SUBJECT: STAFF REVIEW OF MODIFICATIONS TO REVISION 4 OF THE BOILING-WATER REACTOR (BWR) EMERGENCY PROCEDURE GUIDELINES - LIMERICK GENERATING STATION, UNITS 1 & 2 AND PEACH BOTTOM ATOMIC POWER STATION, UNITS 2 & 3

SUBJECT: ACCEPTANCE OF PROPOSED MODIFICATIONS TO THE BOILING WATER REACTOR
(BWR) EMERGENCY PROCEDURE GUIDELINES (TAC NOS. M89489 AND M89629)

SAFETY EVALUATION REPORT
MODIFICATIONS TO THE BOILING WATER REACTOR (BWR) EMERGENCY PROCEDURE
GUIDELINES TO ADDRESS REACTOR CORE INSTABILITIES

Subject of Document: **Review of Proposed Modifications to Emergency Procedure
Guidelines for Anticipated Transients Without Scram Events**

Figure A.1 Effect of Collapsed Level on Core Thermal Power

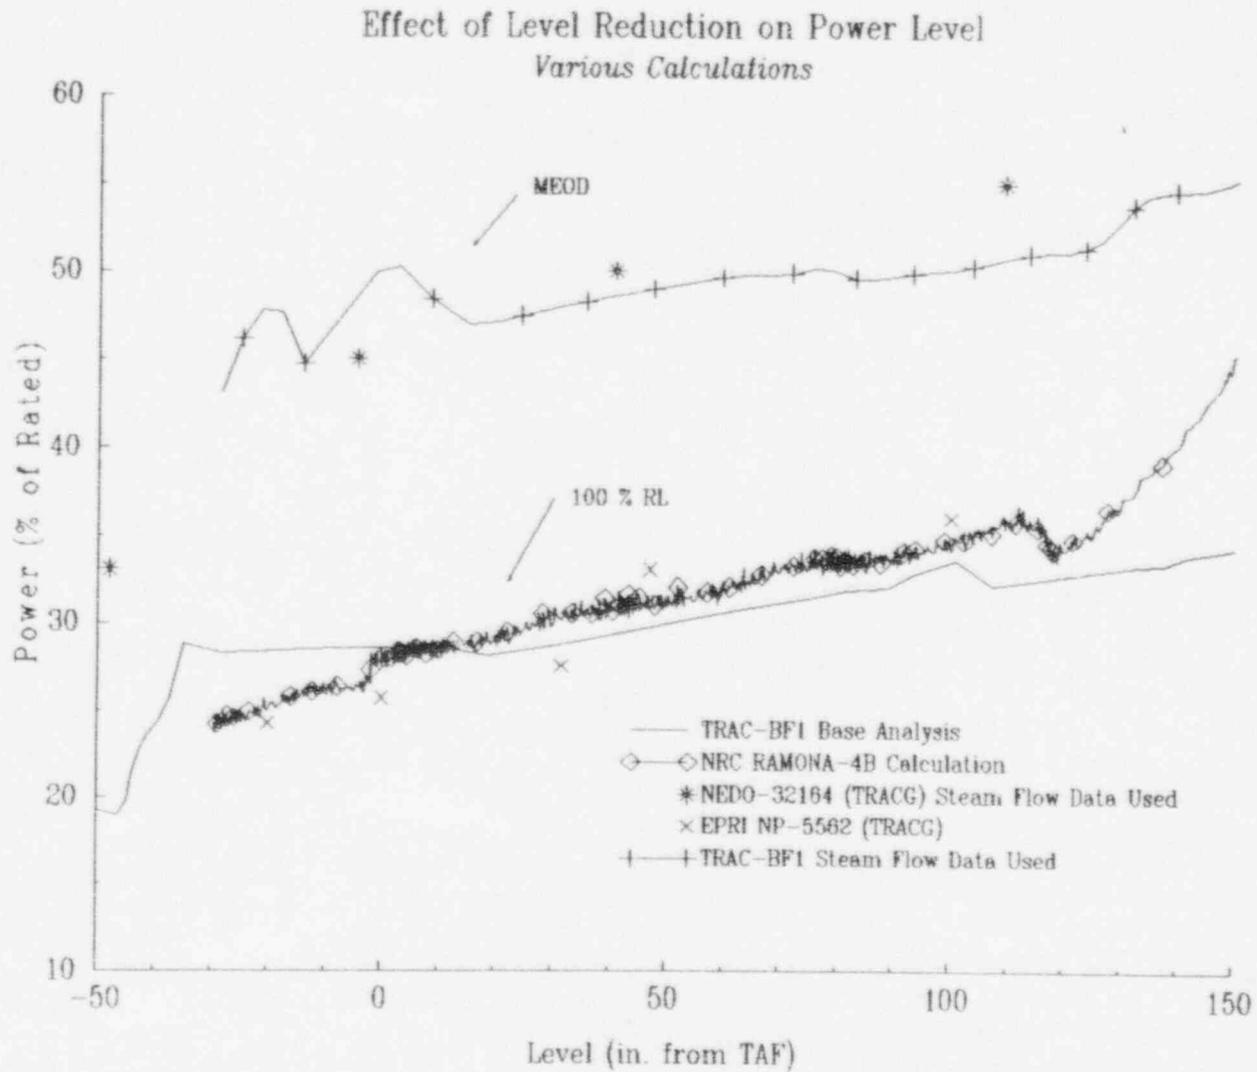
The data from these sources were used to produce Figure A.1 which plots the power as a function of collapsed level. With the exception of the TER results, the staff interpolated core power levels from published plots. For the NEDO-32164 results, the staff used the values for the vessel steam flow and, after accounting for condensation effects in the presence of cold feedwater, determined a reactor power level. This was necessary because the calculation involved an instability and the power level was impossible to determine accurately. Brookhaven National Lab performed additional calculations with RAMONA-4B and the staff completed numerous TRAC-BF1 sensitivity calculations that are not specifically reported here. All of these sensitivity studies show the same trend as the data plotted in Figure A.1.

The results of the suppression pool calculation are presented in Table A.1. As can be seen, the TER results compare well with NEDO-32164 results; the SABRE results show an additional 5 minutes of margin; and EPRI NP-5562 results show an additional 3 minutes of margin. The conclusion that the staff draws from these results is that there remains a great deal of uncertainty in the calculated time to HCTL because of differences in codes and analytical assumptions. Furthermore, the additional time gained at low level is not significant enough to procedurally account for the low probability event of an SLC system failure due to the adverse impact on the higher probability SLC operable event. In other words, the staff

Figure 1. Suppression pool temperatures calculated by TRAC-BF1 following a MSIV isolation ATWS. Downcomer level is maintained at either MSCWL or TAF + 5'.

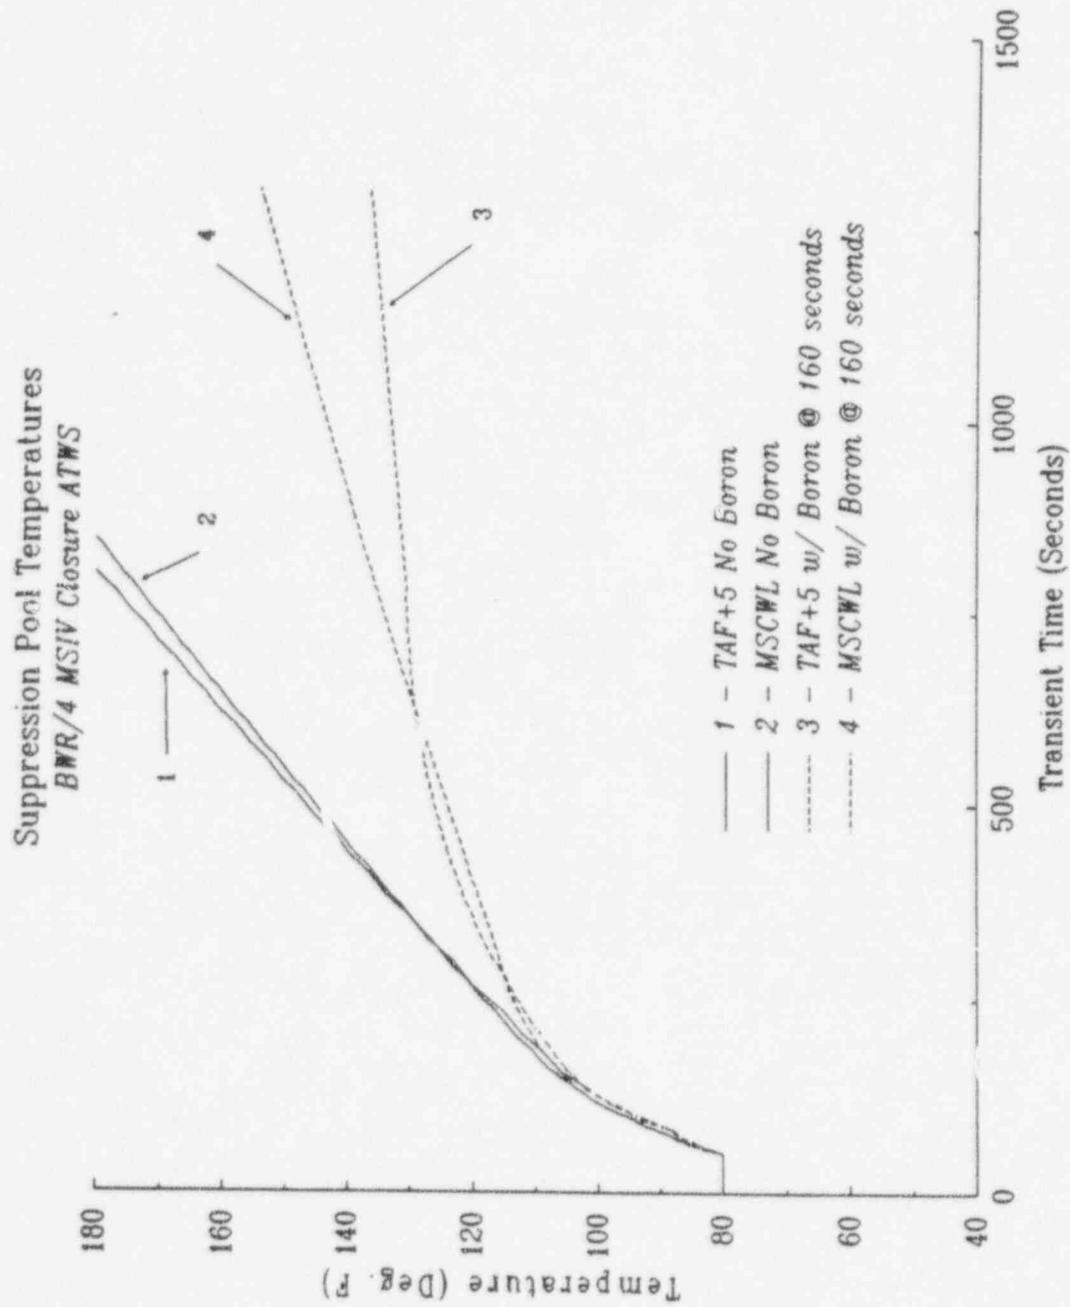
A number of calculations^{4,8} have been performed to determine the effect of controlling at different water levels on the ultimate suppression pool temperature. The results among different calculations vary significantly and indicate a large sensitivity to modeling assumptions. For this reason, NRC has performed a number of calculations for consistent comparison of the two strategies using two well-established codes (TRAC-BF1, and RAMONA-4B). Figure 1 summarizes one set of these staff calculations. This figure shows the suppression pool temperature following a MSIV isolation ATWS event using TRAC-BF1.

The results of the staff calculations also indicate the need for immediate water level reduction once an isolation ATWS event is identified. As seen in Figure 1, the suppression pool is heating up very rapidly for the first few seconds when the level and power generation is high; thus, relatively small changes in assumptions for timing of operator actions in this phase of the transient result in very large discrepancies in the final suppression pool temperature. For example, the calculations reported in ref. 7 indicate that if the operator does not take immediate control of feedwater flow and other injection sources, the suppression pool reaches close to 150°F before the level is lowered and the pool heatup rate is reduced. Staff analyses based on the calculations of ref. 7 indicate that if the EPG procedures (which require prompt operator action) had been followed the final pool temperatures calculated by SABRE for the two level strategies would have been similar to the ones shown in Figure 1.

Figure 2. Comparison of power levels during a MSIV closure ATWS with water level control at MSCWL versus TAF + 5'. Power oscillations are caused by SRV actuation.

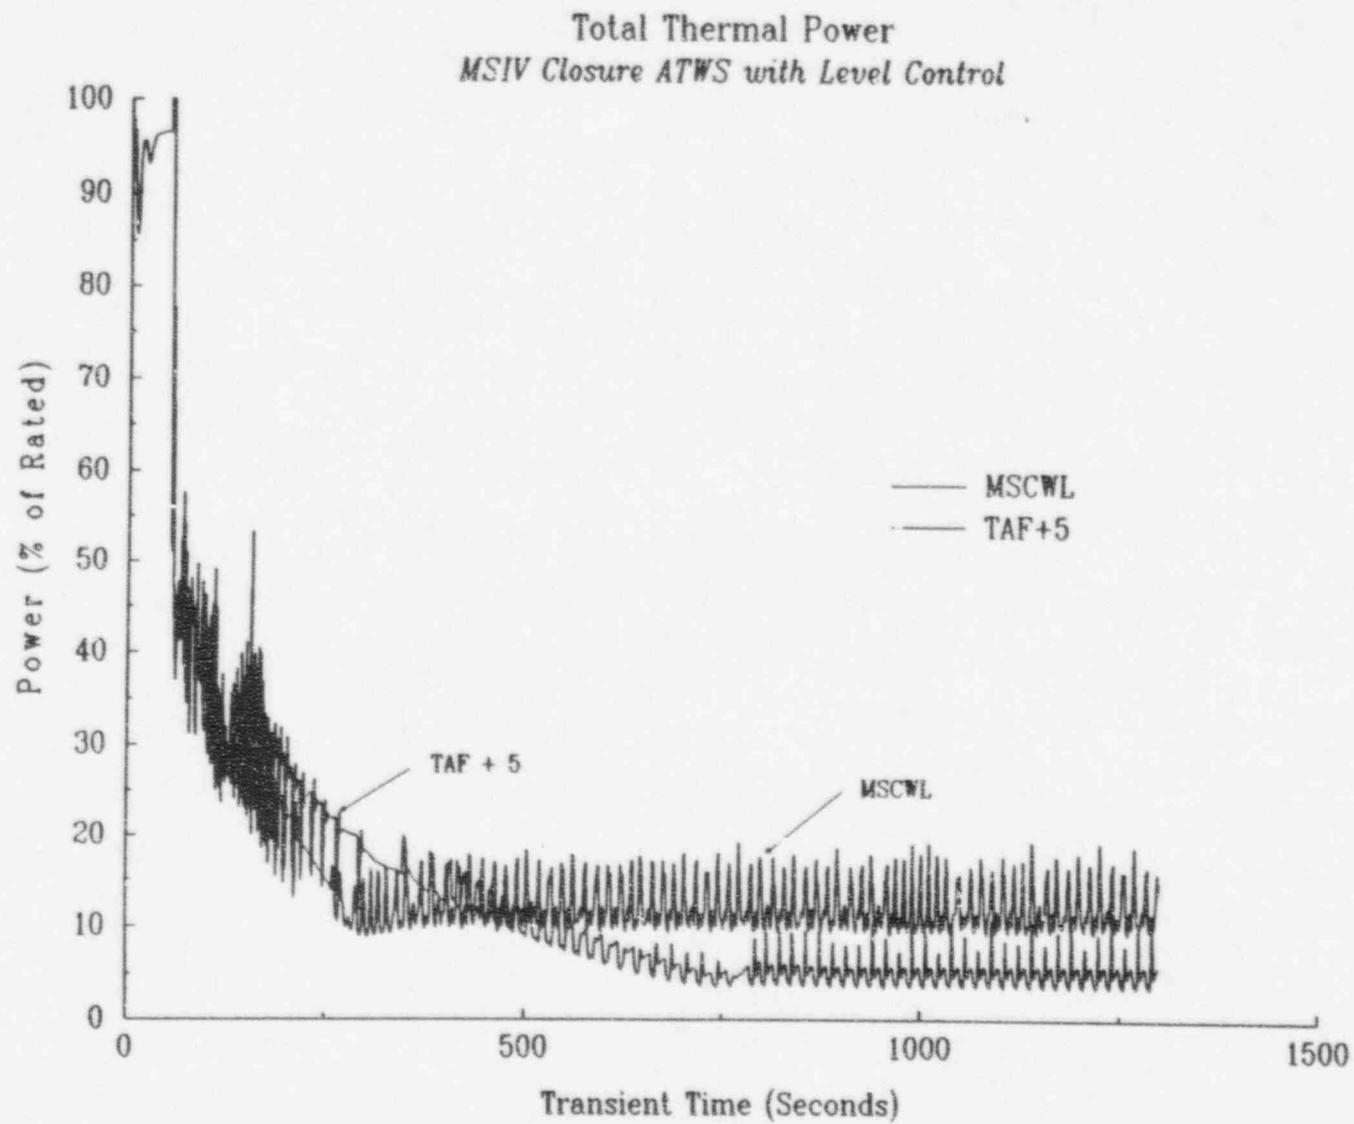
Figure 2 shows the core power calculated by TRAC-BF1 for the same MSIV isolation ATWS events represented in Figure 1, and Figure 3 shows the core boron concentration for the two strategies. These two figures show more clearly the advantage of the higher-level strategy. As a consequence of maintaining the high level, the power generation is higher for the first 500 seconds, but after that the power drops significantly below the MSCWL case, because boron continues to be mixed for 750 seconds until a concentration of 300 ppm is reached. This boron concentration is sufficient to reduce the power and drop the flow to 5% (the flow at which boron is assumed not to mix), as seen in Figure 4.

Figure 5. Comparison of core average void fraction for a MSIV closure ATWS event with two different level control strategies.

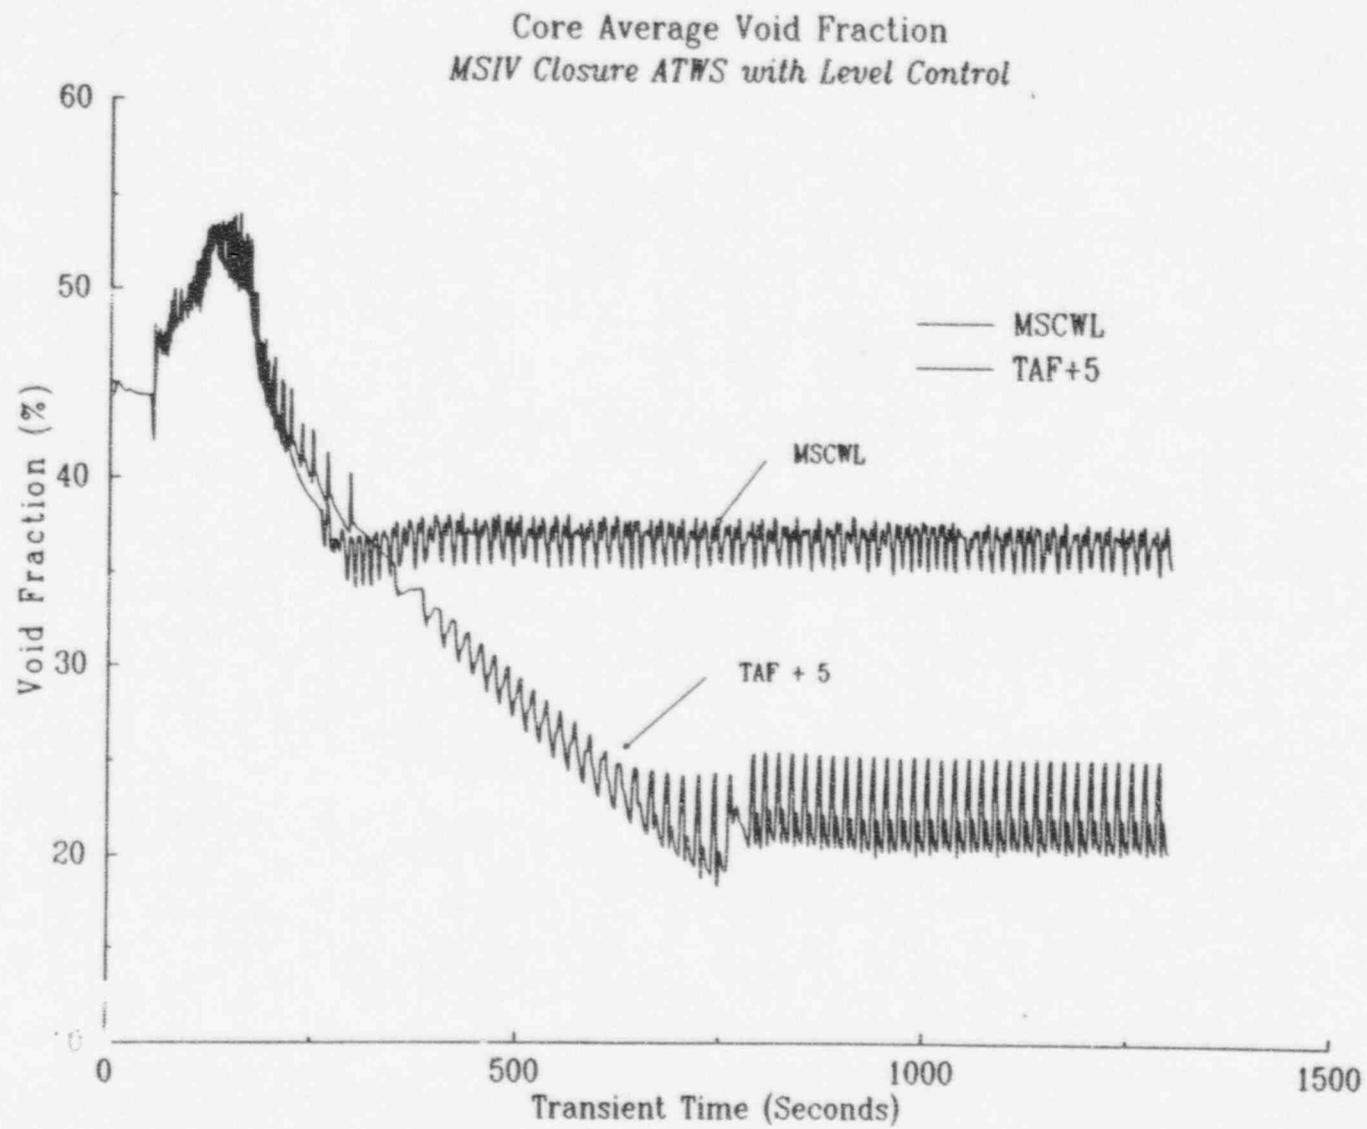
Figure 5 shows the core average void fraction for the two level-control strategies studied. This figure shows that as expected, to maintain the level at MSCWL, the reactor requires a higher void fraction than when the level is higher at TAF + 5'; thus, a higher power is required at the lower level to maintain the same flow (approximately 5%).

The NRC calculations have also shown that the two-phase level is well-above the core (indeed, in most cases, the two-phase level is at the separator level) even when the level is at the MSCWL. As seen in Figure 5, the core average void fraction is lower with the level at MSCWL than at nominal conditions (time zero in Figure 5). This fact indicates that the core is likely to be covered with a two-phase mixture. The core coolability is confirmed by studying the peak clad temperatures calculated by TRAC-BF1. Figure 9 represents a composite of ten different TRAC-BF1 calculations, and it shows the maximum clad temperature in the low-power channel (expected to have the limiting performance). This set of TRAC-BF1 calculations includes collapsed water levels from TAF + 5 to MSCWL, and it shows that the clad temperature is well within acceptable limits. Indeed, for most transients, the peak clad temperature is lower than at rated conditions (time zero).

Figure 6. TRAC-BF1 and RAMONA-4B calculated power as a function of downcomer water level with 25 °C feedwater. Sharp drop in power at TAF - 40" (TRAC-BF1 calculation) corresponds to flow stagnation.

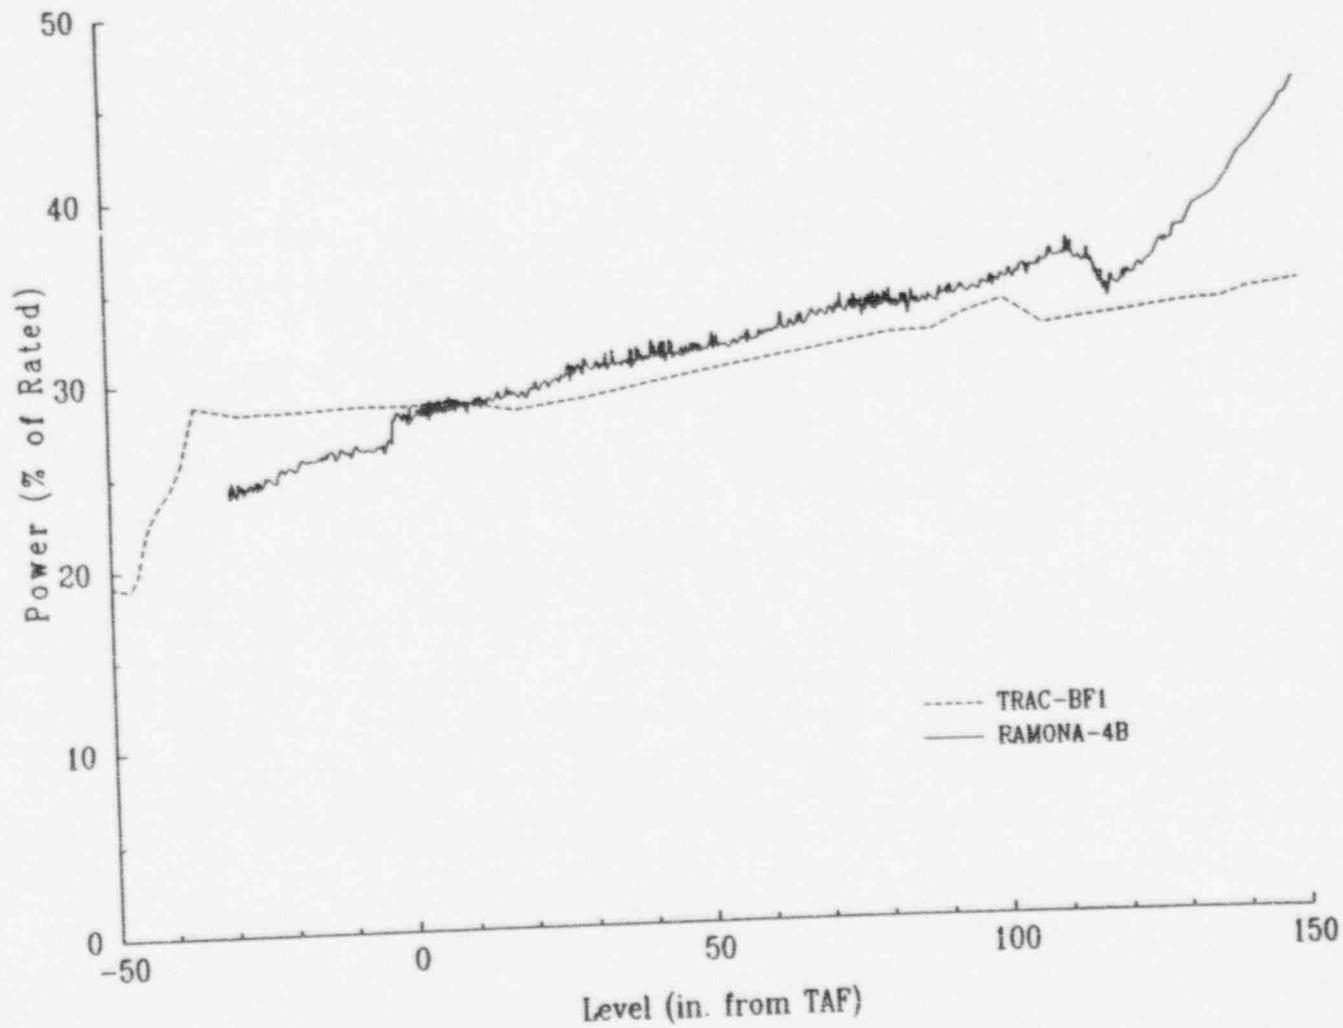
An unexpected result of the staff calculations is the small dependency observed between power and level once the level is lowered below TAF + 5'. Figure 6 shows the core thermal power as function of downcomer water level. This figure has been produced by plotting the power and level during a TRAC-BF1 and a RAMONA-4B calculation in which the feedwater flow is slowly ramped down to zero. We can observe that both codes, TRAC-BF1 and RAMONA-4B, predict that the dependency between power and water level is fairly flat around the TAF area. This is the reason why the differences between the two level strategies are not as large as expected when the SLC system fails.

The sharp step change in power seen in the TRAC-BF1 calculation shown in Figure 6 at around TAF - 40" corresponds to the stagnation of the external flow recirculation path. The RAMONA-4B calculation (which does not correspond to the same reactor or initial conditions that the TRAC-BF1 calculation) predicts slightly higher recirculation flows than TRAC-BF1 and does not predict flow stagnation even for a water level as low as the top of the jet pumps (TAF -50"). For levels below TAF - 40", the core inlet flow is greatly reduced and equals only the flow of steam leaving the core; this results in a significantly lower power. The value of the flow-stagnation power calculated by TRAC-BF1 is slightly less than 20%. This number was previously assumed to be of the order of 8% based on an extrapolation of a number of REDY analyses.¹⁰ The larger value of the flow-stagnation power is consistent with other BWROG calculations² and is attributed to the fact that REDY uses a multiplicative slip void model, which is incapable of predicting accurately the void fraction distribution under flow-stagnation conditions.

Figure 9 Composite of ten different TRAC-BF1 ATWS calculations showing the maximum clad temperature of the low-power channel.

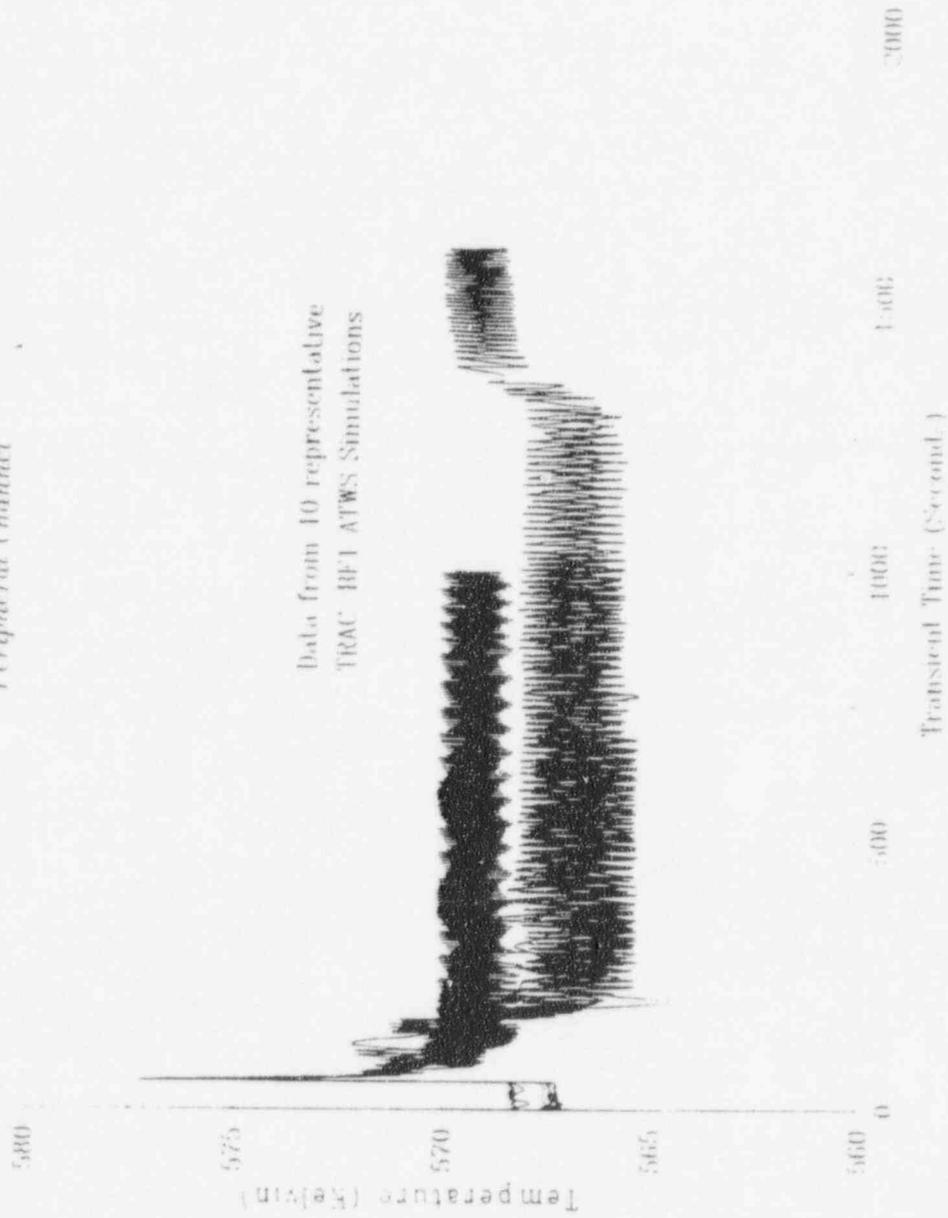
Figure 9 shows only the low-power peripheral channel for ten different TRAC-BF1 runs. Figure 10, in contrast, shows a composite of all the peak clad temperatures calculated by TRAC-BF1 for all channels in the two base runs: MSCWL and TAF + 5' level control with boron injection. This figure confirms that the peak clad temperature is within acceptable bounds, and it indicates that the two-phase level is well above the top of active fuel even when the collapsed water level is at the MSCWL.

Condensation-induced pressure fluctuations (concern (3) above) have been addressed in part by the TRAC-BF1 and RAMONA-4B calculations. Both of these codes have a mechanistic model for heat transfer between the subcooled liquid and steam phases; therefore, they compute the average equilibrium pressure that is reached in the node where steam condensation takes place. The result of these calculations exhibit pressure and power oscillations that are correlated with SRV cycling, but the magnitude of these oscillations is acceptable (see Figure 2), and it only results on peak clad temperature oscillations of the order of 5 °C, as seen in Figs 9 and 10.
